Meeting of the Central Valley Flood Protection Board
July 22, 2016

Staff Report – Encroachment Permit

City of Roseville
Oak Ridge Drive Bridge, Placer County

PERMIT NO. 19103 BD

GENERAL PLAN

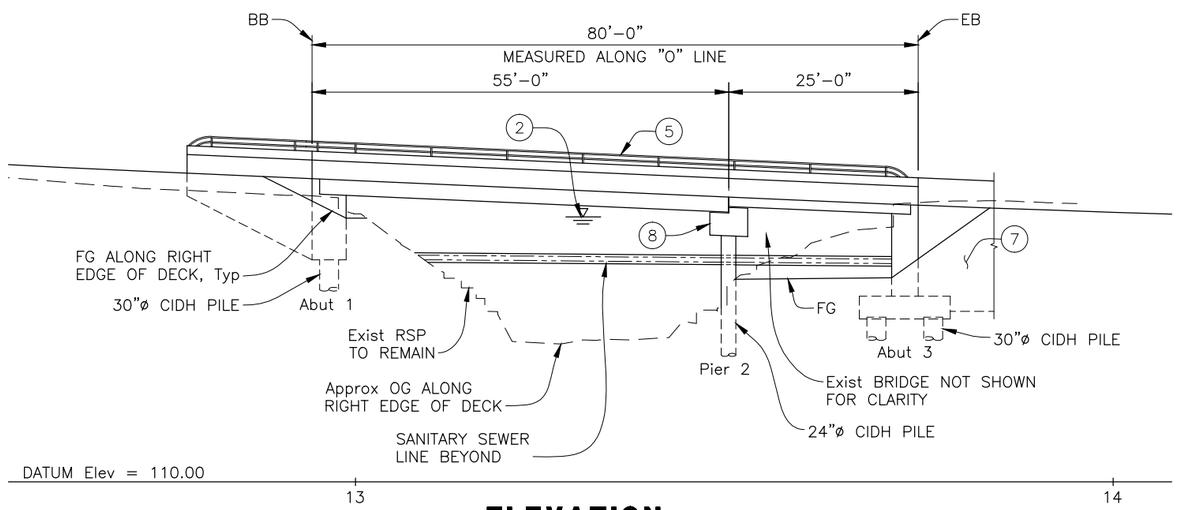
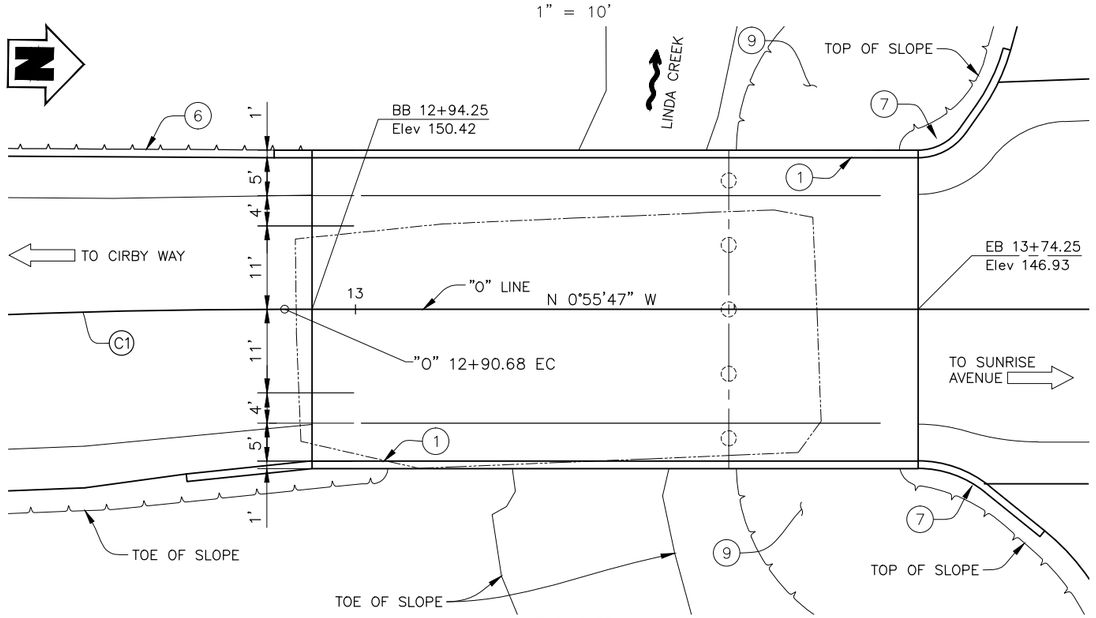
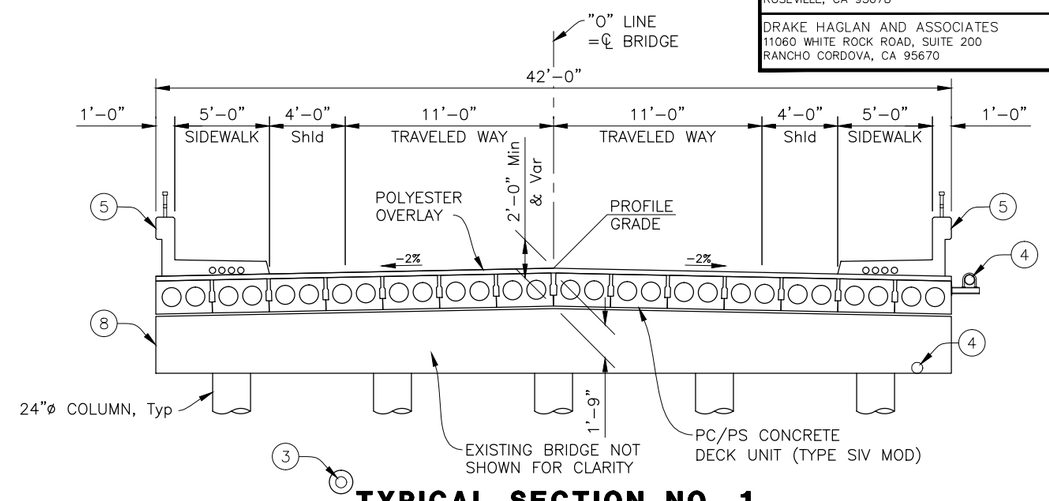
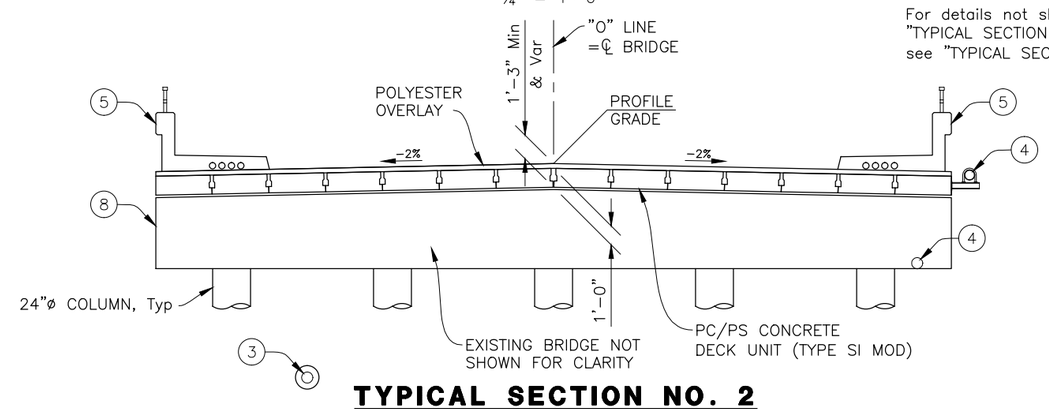
The proposed bridge will have an approximate span of 80 feet in length and 42 feet in width (Attachment C). Linda Creek is listed as a regulated stream in California Code of Regulations (CCR) Title 23, Division 1, Article 8, Section 112, Table 8.1. There are no levees along Linda Creek in the project area. The proposed project will be in compliance with all CCR Title 23 standards.

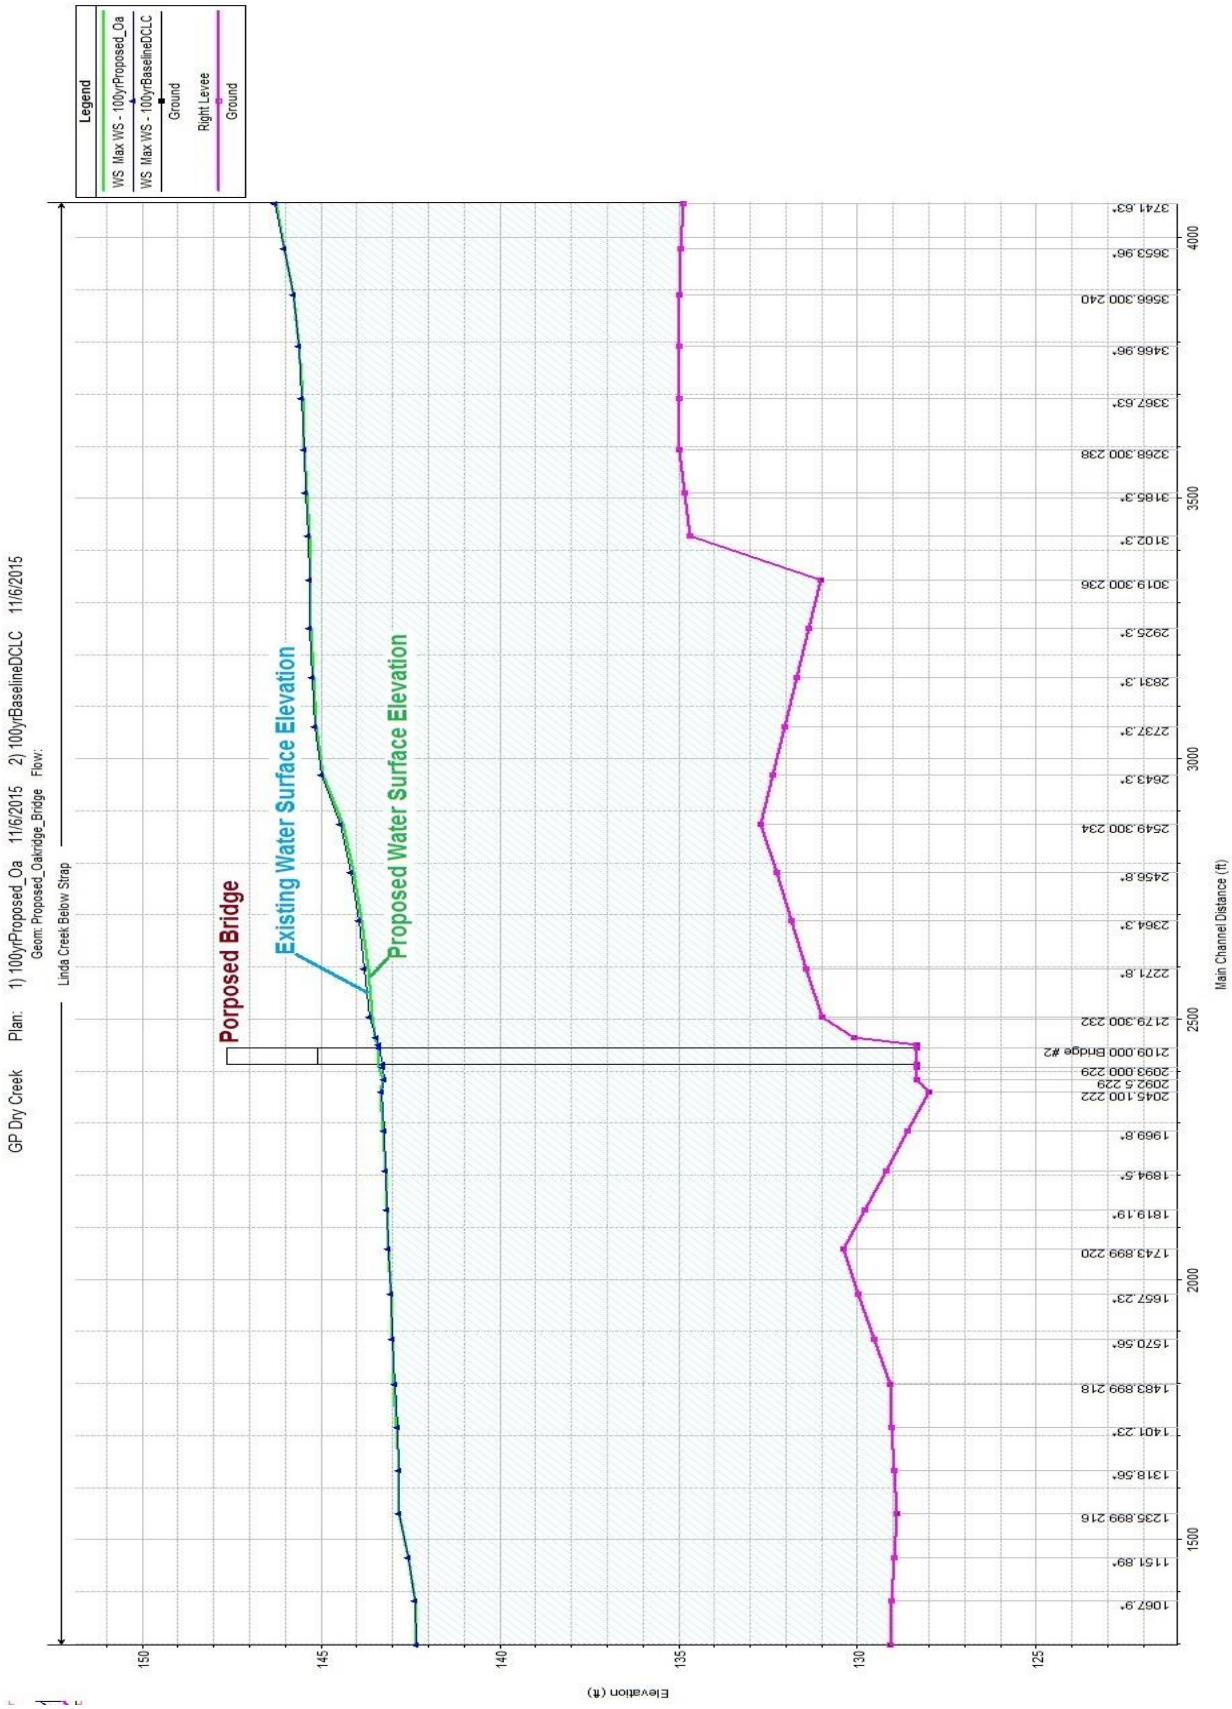
The lowest point on the bridge will be a minimum of 2.4 feet above the water surface elevation (WSE) at the design flow. The HEC-RAS analysis showed that all computed water surface elevations and velocity changes due to the new bridge are minor, with an increase of 0.05 feet in WSE and a decrease in velocity of 1.04 feet per second due to the bridge's increased span length (Attachment D).

Based on Board staff's review of the proposed projects, it is anticipated that there will be no significant adverse hydraulic impacts to the Linda Creek channel or floodway.
